AMERICA'S CUP 36

AC75 Interpretation 005

AC75 Class Rule Version 1.2 issued 10 December 2018

figure 2.0

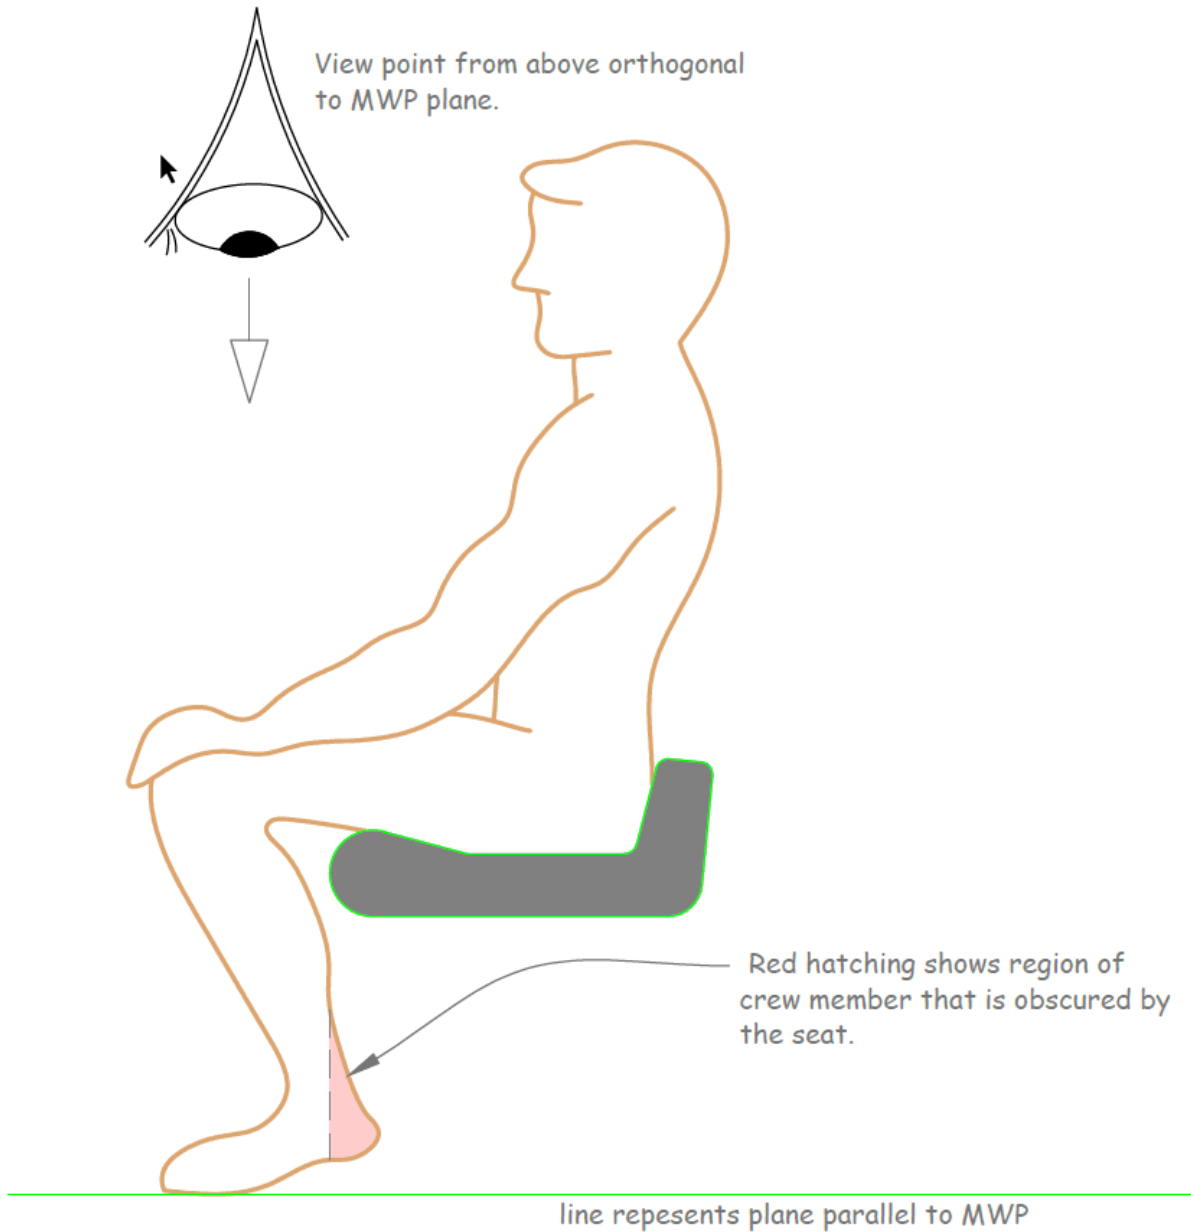
6. Figure 2.0 shows a crew member sitting on seat, with parts of their feet lying below the seat. If a crew member remains in this position for a sustained period, would they be infringing on Rule 12.11?

6. Yes. In order to be exempt, any "other component" must meet all three conditions in rule 12.11. Due to the position being held for a sustained period, the "occasional" condition is not met.
